Important Notices

TOSHIBA Microcontrollers TLCS-870 Family TLCS-870/C1 Series

Restrictions on the Voltage Detection Circuit

Datasheet Corrections: Electrical Characteristics of the Power-On Reset Circuit

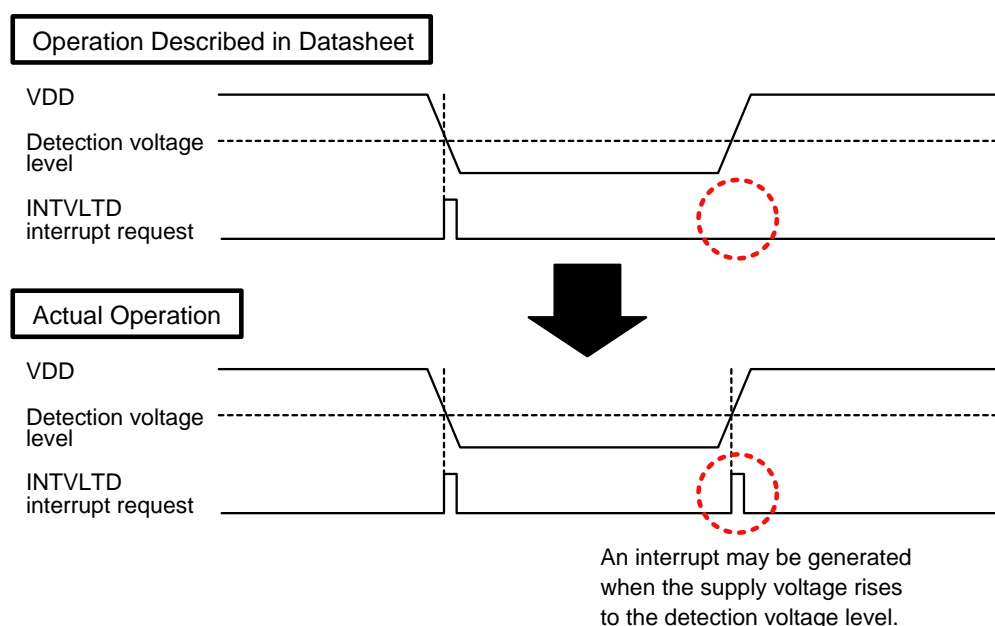
When interrupt generation is enabled in the voltage detection circuit, an INTVLTD interrupt request may be generated not only when the supply voltage falls to the detection voltage level, but also when it rises to the detection voltage level.

In ICE mode of the In-Circuit Emulator (TMP89C900), no interrupt request is generated when the supply voltage rises to the detection voltage level. Therefore, with products supporting the In-Circuit Emulator (TMP89C900), the interrupt generation operation may differ between the development tool and the actual product.

The SRSS bit in the voltage detection control register 2 (VDCR2) provided for releasing STOP mode by voltage detection cannot be used because it does not function as expected.

Do not use the INTVLTD interrupt for voltage detection. The voltage level should be regularly checked using other timing such as the execution cycle of the main program. VDCR1<VDxSF> (x=1, 2) can be used to check the voltage level. However, if the operating voltage is near the detection voltage, the VDCR1<VDxSF> value may become unstable. It is recommended that VDCR1<VDxSF> be tested multiple times to determine the voltage level.

Always set VDCR2<SRSS> to "00". Use the STOP pin to release STOP mode.
